Planning Commission Minutes
October 24, 2024

22. (PUD-2030) Application by Skyline River Front, LLC and Exchange Avenue Properties, LLC to rezone 1501 Exchange Avenue from I-2 Moderate Industrial, I-3 Heavy Industrial, SPUD- 827 Simplified Planned Unit Development, and SRODD Scenic River Overlay Design Districts to PUD-2030 Planned Unit Development, and SRODD Scenic River Overlay Design Districts. Ward 6.

STAFF REPORT
The City of Oklahoma City
Planning Commission
October 24, 2024

(PUD-2030) Application by Skyline River Front, LLC and Exchange Avenue Properties, LLC to rezone 1501 Exchange Avenue from I-2 Moderate Industrial, I-3 Heavy Industrial, SPUD-827 Simplified Planned Unit Development, and SRODD Scenic River Overlay Design Districts to PUD-2030 Planned Unit Development and SRODD Scenic River Overlay Design Districts. Ward 6.

**PUD-2030 Exhibit B -
Master Development Plan**

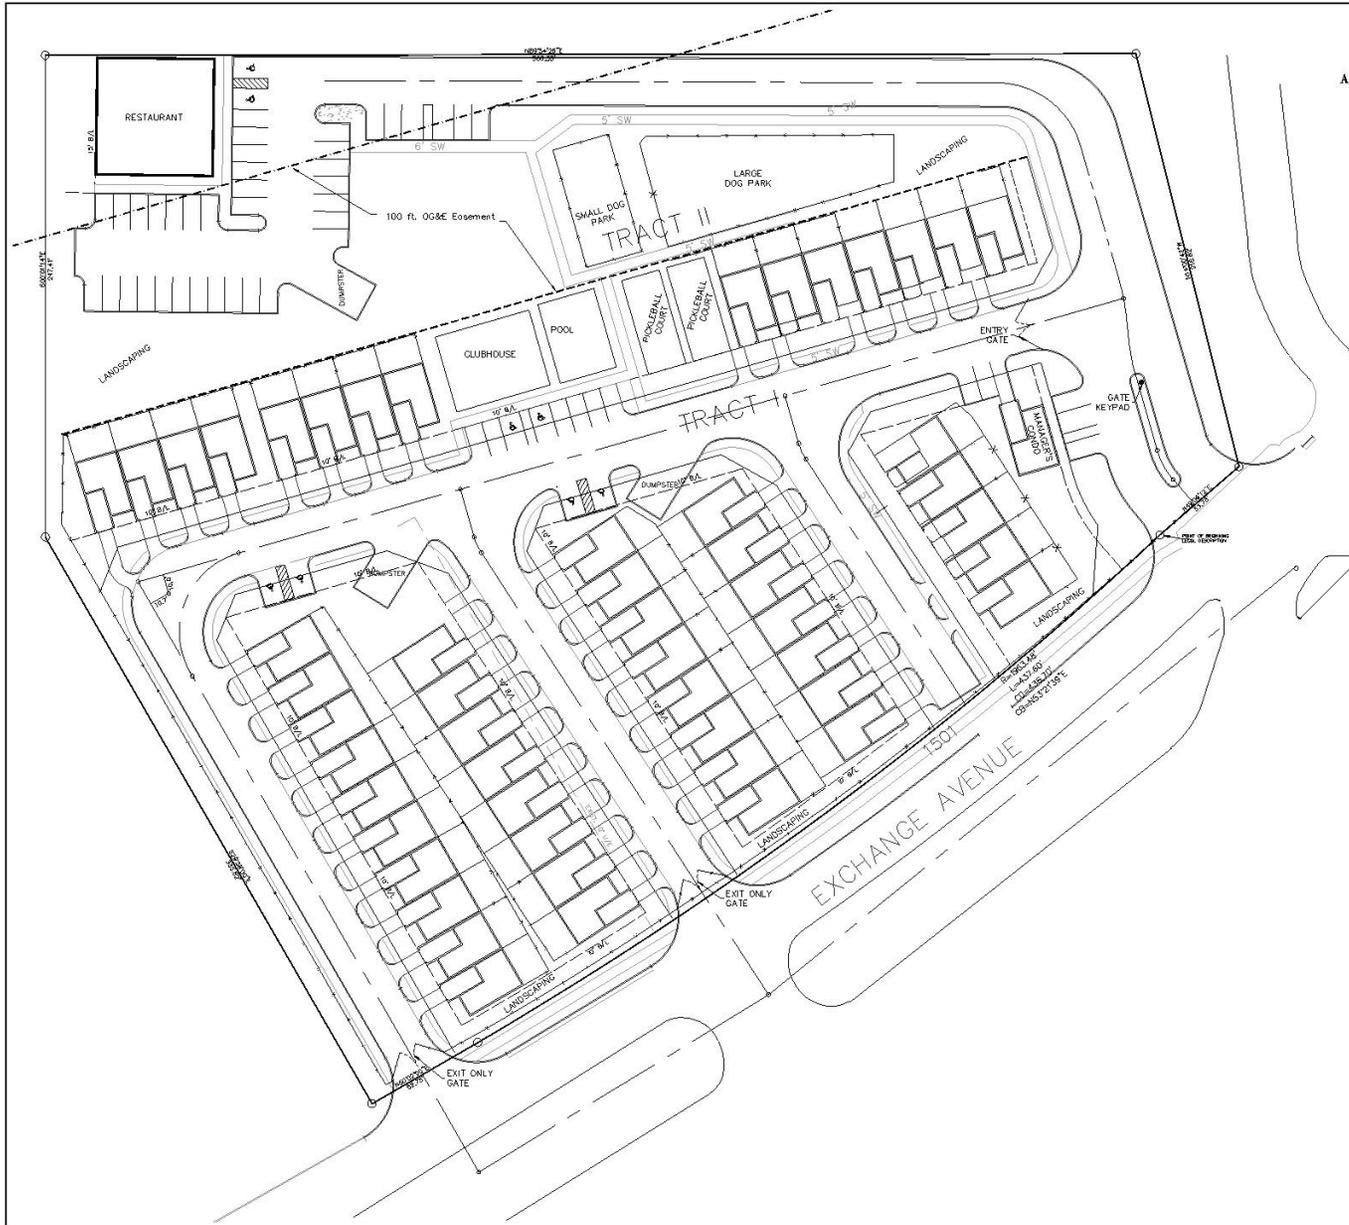
- 16) Exchange Avenue is shown on the Functional Classification Plan as a Major Arterial. Revise minimum driveway spacing to 200 feet.
- 17) The Master Development Plan shows 3 drives onto Exchange Avenue. Revise the Master Development Plan to show only 2 drives to make it consistent with the PUD language. *[Revised by applicant to allow three drives]*
